## Application for Works Approval

<b>Works Approval Number</b>	W6934/2024/1
<b>Applicant</b>	Golden Grove Operations Pty Ltd
<b>ACN</b>	114 868 325
<b>File number</b>	DER2024/000148
<b>Premises</b>	Golden Grove Mine M59/89, M59/90, M59/363 and part of M59/3 YALGOO WA 6635  As defined by the premises map attached to the issued works approval
<b>Date of report</b>	09 September 2024 (FINAL)
<b>Decision</b>	Works approval granted

Figure 8: TSF4 monitoring and seepage collection bore locations

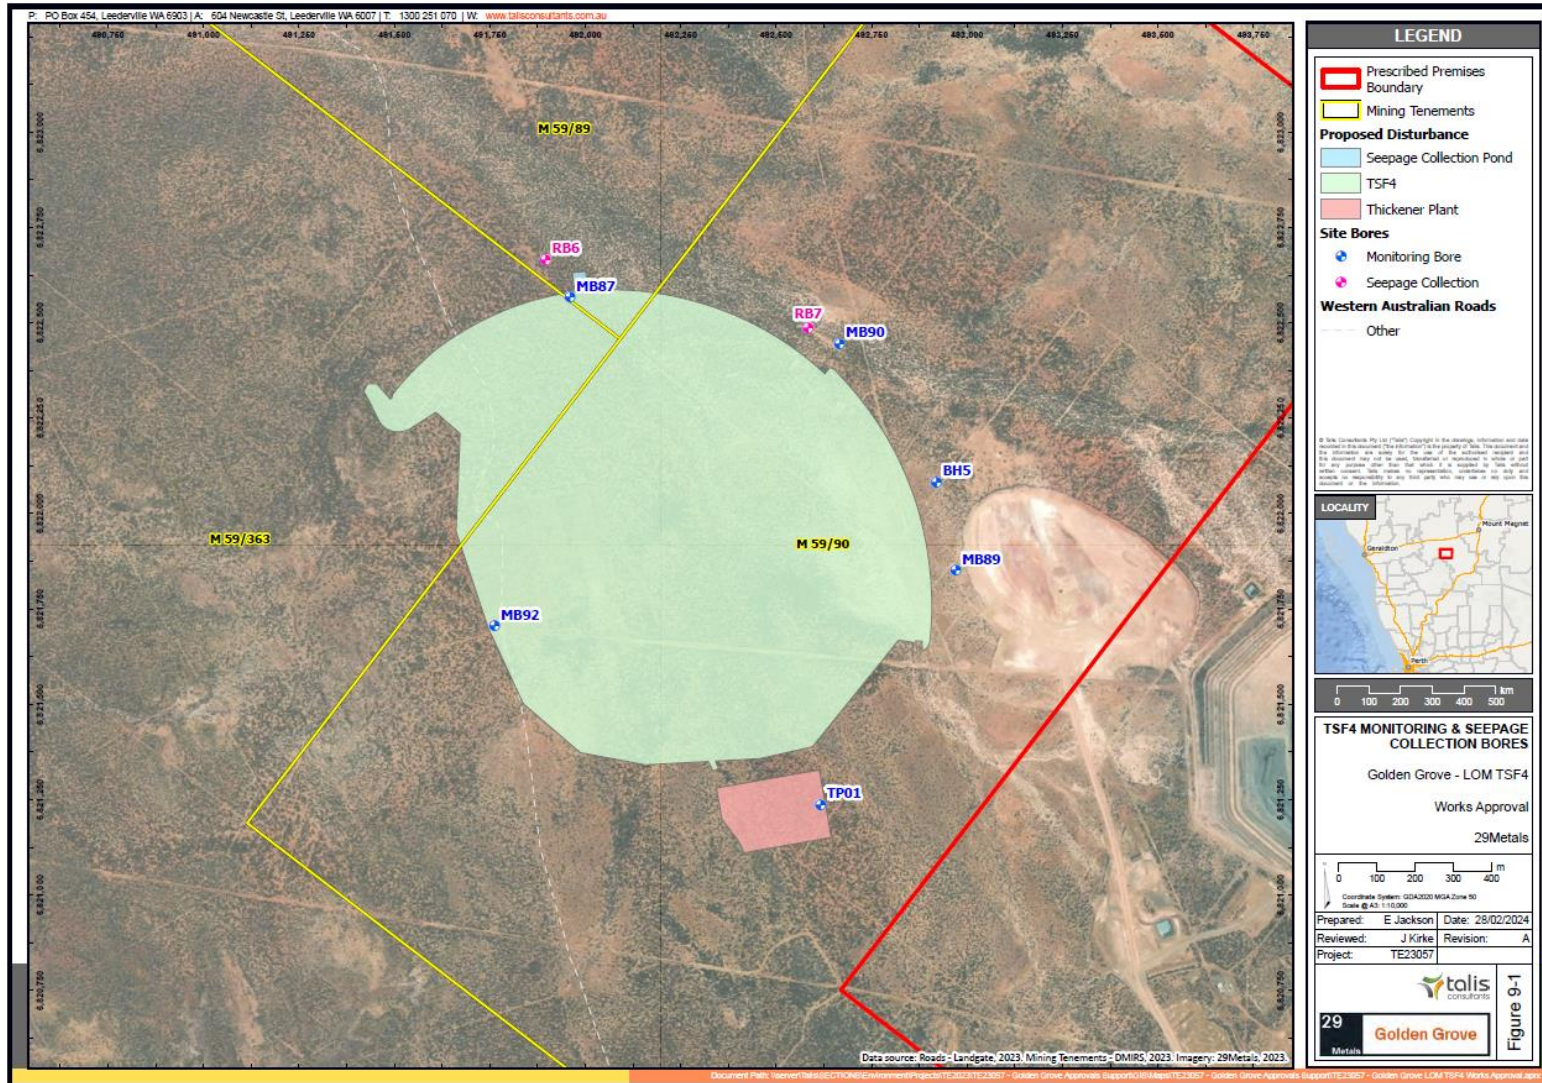
The applicant has proposed groundwater monitoring bores as shown in Figure 8.

MB87, MB89, MB90, MB92 and BH5 have already been constructed. TP01 is yet to be constructed so installation requirements have been imposed through condition 3.

**Figure 12: Recommended location for an additional groundwater monitoring bore**

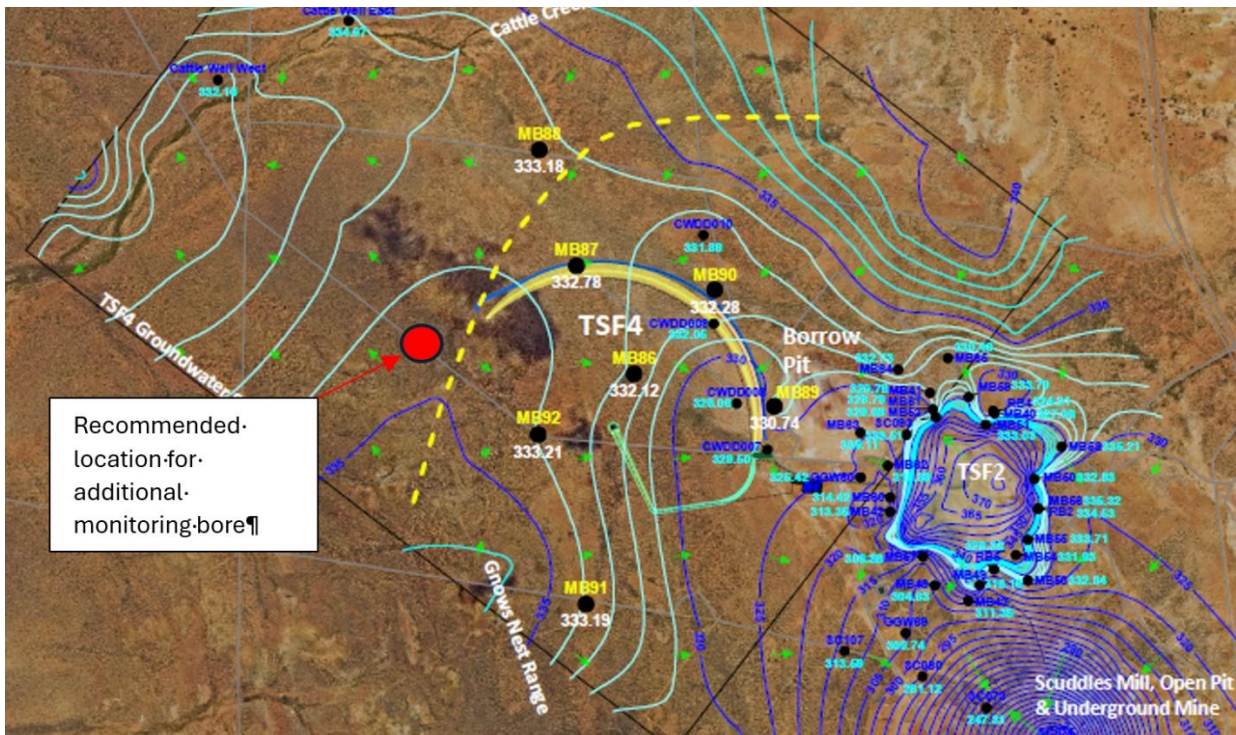
The application (Talis 2024) was referred internally. A department hydrogeologist has made the following recommendation:

- *The position of a groundwater divide north of the proposed TSF4 is uncertain and could be backed up further with an additional monitoring bore. The additional bore could be placed to the southwest of MB88 to ensure the local flow direction during mining operations is not flowing toward Cattle Creek and that there is in fact a divide. For example, in the image below, placement in this general area should suffice.*

Based on the above, the requirement to install a new bore south-west of MB88 in the vicinity of the red dot shown in Figure 12 has also been imposed through condition 3.
